CONDITIONS OF APPROVAL:

Engineering - Site Plan Checklist

Ranco Farms Subdivision, Lot 2, Revision 2, Site Plan (Mallory Green) - submittal 003.pdf

26. EPSC

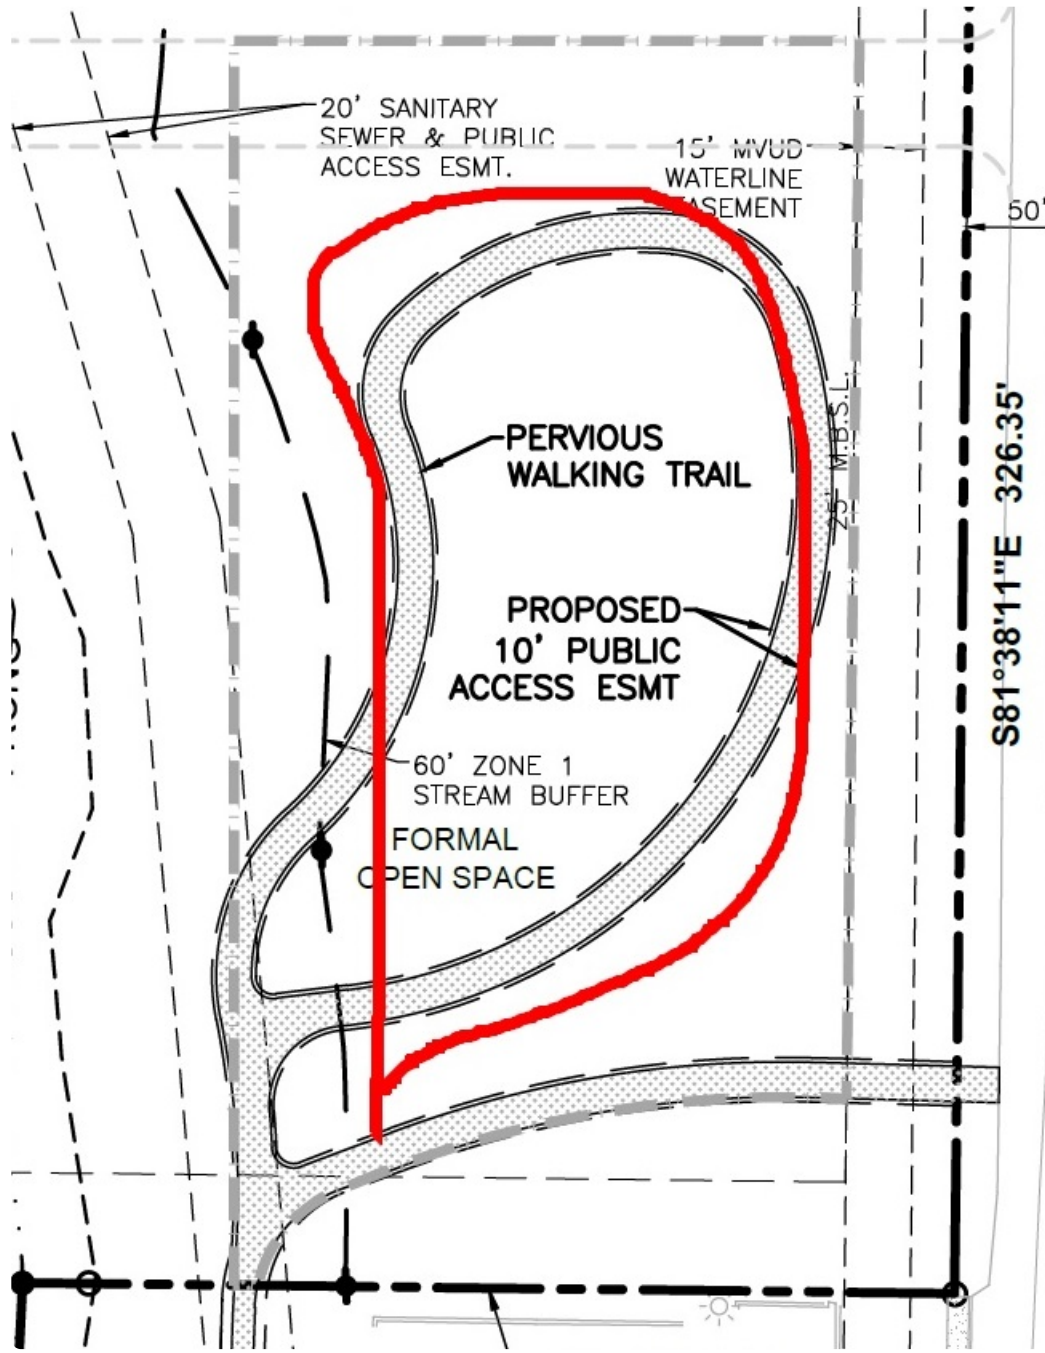
Applicant shall provide filter ring detail and detail how the measure will adequately provide sediment control.
